LINOTYPE IMPROVEMENT INFORMATION SHEET

NO. 349

L.H. VISE JAW CABLE GUARD (HYDRAQUADDER)

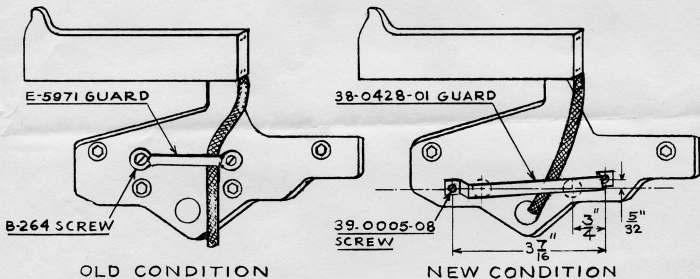
This guard which holds the L.H. Vise Jaw Wire Cable in position has been redesigned to assure the free movement of the cable and increase its wear life.

Can be applied to all outstanding Linotypes equipped with Hydraquadder by ordering new guard 38-0428-01 and two screws 39-0005-08, and drilling and tapping two 8-32 holes as shown.
